PUBLIC UTILITIES COMMISSION

Re: Data Request #14 for the SCE Ivanpah-Control (I-C) Project (A.19-07-015)

DR 14.1: Biological Resources (Proposed Project and LADWP Alternatives)

Legend from Appendix A Map:**DR 14.4: Visual Photosimulations (LADWP Alternatives)**

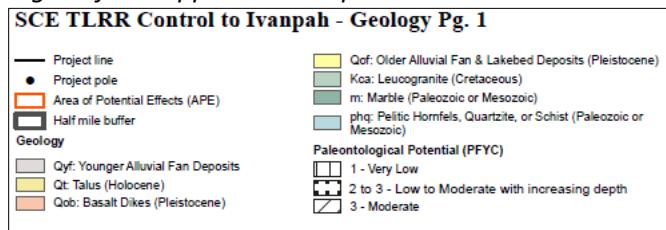
For the EIR to present a parallel analysis of the LADWP Alternatives and compare these route segments with the equivalent segments of the proposed project, we will need PFYC data and geologic mapping for the three alternative segments, as was presented in Appendix A of the 2020 report (see legend excerpt below). We do not need any other updates to the report. We expect that this is a desktop exercise.
